NOTICE OF DECISION

DECISION OF THE PLANNING COMMISSION

**CLASS 3 DESIGN REVIEW / CLASS 3 SITE PLANNING REVIEW / CLASS 2
ADJUSTMENT / CLASS 2 DRIVEWAY APPROACH PERMIT CASE NO.: DR-
SPR-ADJ-DAP19-01**

SUMMARY: A consolidated application for a Design Review, Site Plan Review, Driveway Approach Permit, and Class 2 Adjustment to allow for the development of a proposed triplex on property located at 2425 Market Street NE.

PROPOSED SITE PLAN

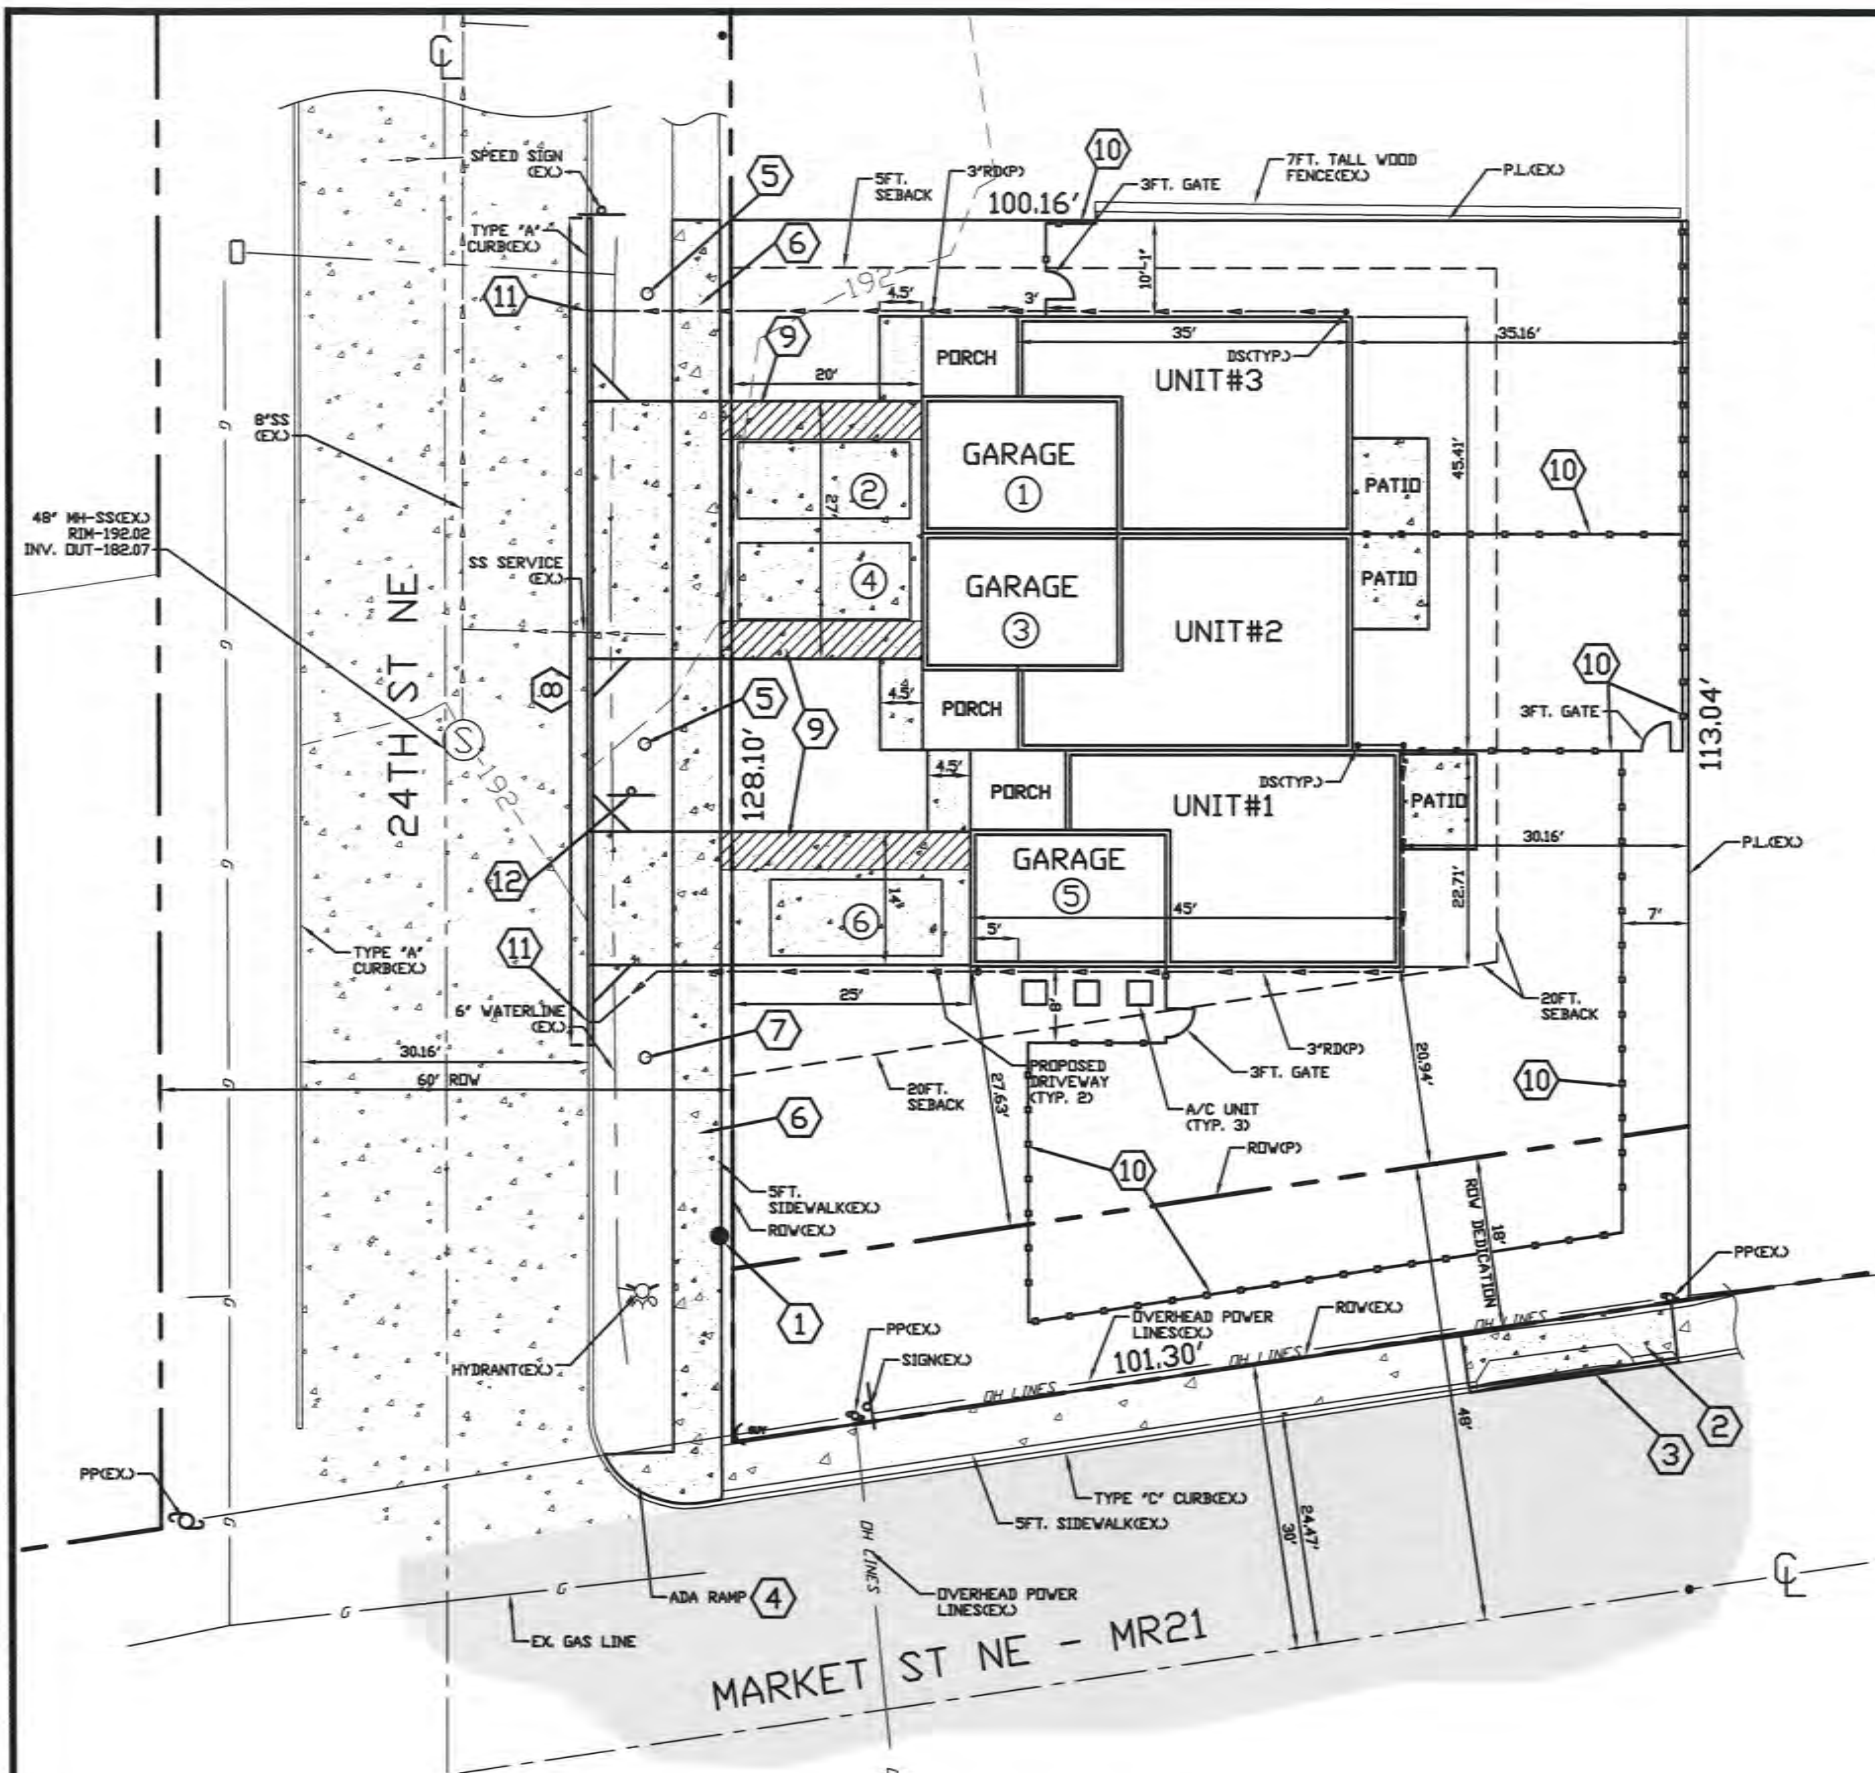
Finding: The proposed site plan, provided by the applicant, depicts all three units will have entries facing the right-of-way for 24th Street NE. Each of the entryways will have a covered porch as shown on both the site plan and elevation drawings for the proposed triplex.

Finding: The development proposal does not include common open spaces. As shown on the applicant's proposed site plan, a 6-foot tall sight obscuring cedar fence is proposed along the side and rear yard of the triplex. The parking spaces are proposed to abut 24th Street NE. The landscape within the front yard abutting the right-of-way and parking areas is of a scale which will allow clear visual surveillance of the parking areas and dwelling unit entryways. The Planning Commission finds that as proposed, this design standard is met.

Based on the above identified minimum bicycle parking requirements, the proposed multiple family development requires 4 bicycle parking spaces. The applicant did not identify bicycle parking on the site plan. To ensure this standard is met, the Planning Commission imposes the following condition of approval:

Condition 2: At the time of building permit application, the applicant shall submit a revised site plan indicating the location of four bicycle parking spaces for the multifamily development. Bicycle parking may be provided in the garages for each dwelling unit.
